MAXWELL PROJECT

Review of adequacy of rehabilitation of Maxwell Underground and Maxwell Infrastructure including Mine subsidence

Peter Scott

24 November 2020

Figure 5-6: Layout of Longwalls in Woodland Hill Seam

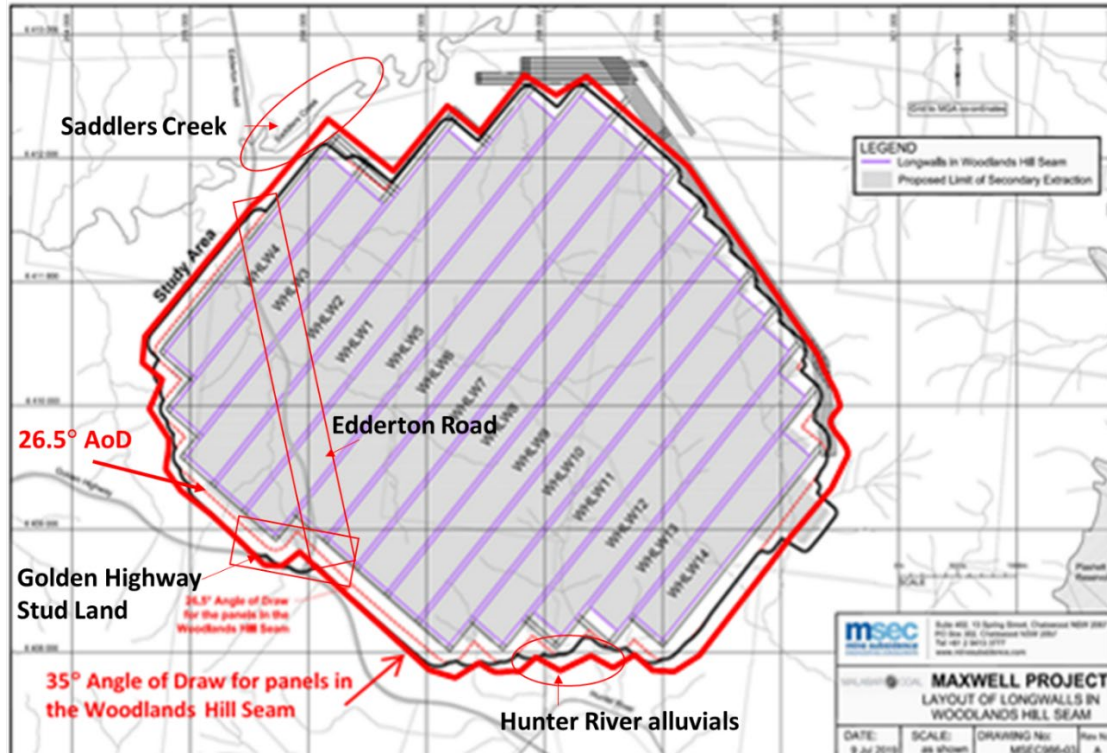
While 26.5° angle of draw is used when predicting limits of subsidence, if the angle of draw is greater than 26.5° say 35° - 40° then the area of subsidence deformation becomes closer to the Hunter River: based on the Woodlands Hills seam minimum distance from 35° angle of draw becomes 270m, and is a 100m closer to the alluvial flats. Figure 6 shows estimated limits of deformation for Angles of Draw for 26.5° and 35°. The application of 35° AoD hasn't been modelled but illustrates the need for a range of different angles of draw to be assessed and modelled as part of the environmental impact assessment process, not just the rule of thumb. The EIA process must look at a wide range of parameters that can be and are used to define an indicate potential subsidence deformation and potential extent of surface and near surface effects. This process also needs to be coupled with known geology and geotechnical data for the Maxwell mine as recommended by MSEC.

MSEC (2019) does recommend that *“Extraction Plans for the Project include a subsidence effects monitoring program to monitor subsidence movements, including valley closure, and compare measured movements with predictions. Further recommendations for the Hunter River were provided by the specialist surface water and groundwater consultant for the EIS, including the development and implementation of a monitoring program”*. This suggests need to cover uncertainty about predictions of subsidence impacts on the Hunter River and its alluvial flats.

Figure 5-7: Extent of Maxwell underground Development

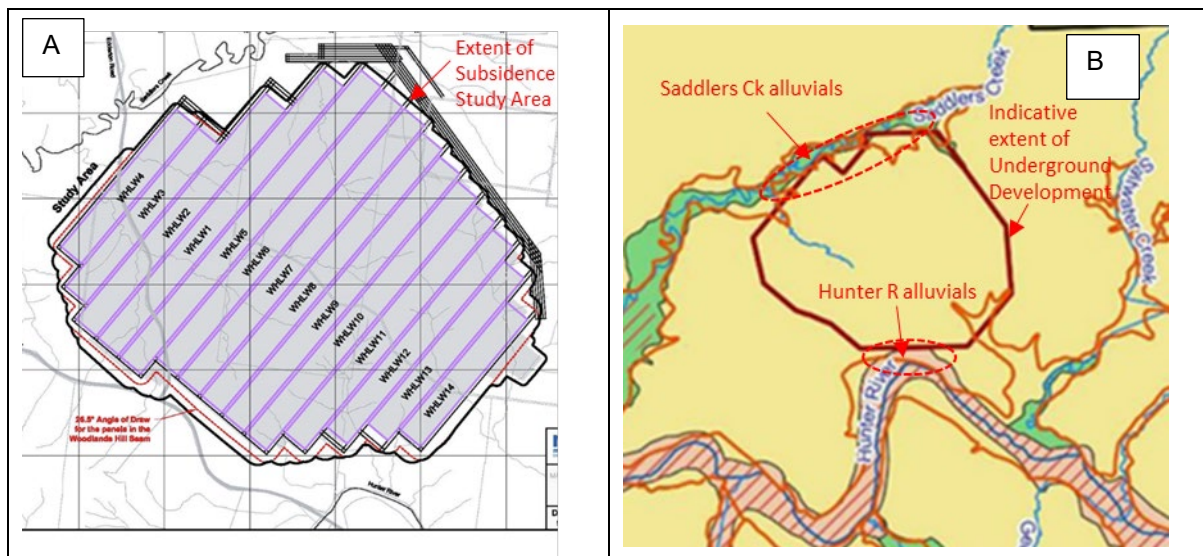
Finally there is doubt on the values quoted in the EIS for mining panels distances from key natural and built features such as: Hunter River, Hunter River alluvials; Saddlers Creek and Saddlers Creek Alluvials; Golden Highway and Stud Land etc.

Figure 5-7 shows two location plans: A is from the EIS Appendix A – MSEC subsidence assessment, and B is from the EIS Appendix B: HydroSimulations groundwater report. The plan from the HydroSimulation groundwater report shows the indicative extent of Underground Development boundary limits are much closer to the natural and built features, including the Saddlers Creek alluvials and the Hunter River alluvials, than the plan of the Study Area from the MSEC subsidence report. The outline of the indicative extent of underground development is used throughout the EIS. Also the uncertainty of accurately predicting the extent of subsidence increases the risk of impacts on the natural environment features. There is nothing stated in the EIS that coal extraction will not mine up to the Indicative extent of the underground development. Given the importance of proximity to natural and built features for assessment of risk of impact from subsidence this should have been picked up by DPIE and at least questioned, and importantly insisted a risk assessment, which it wasn't.
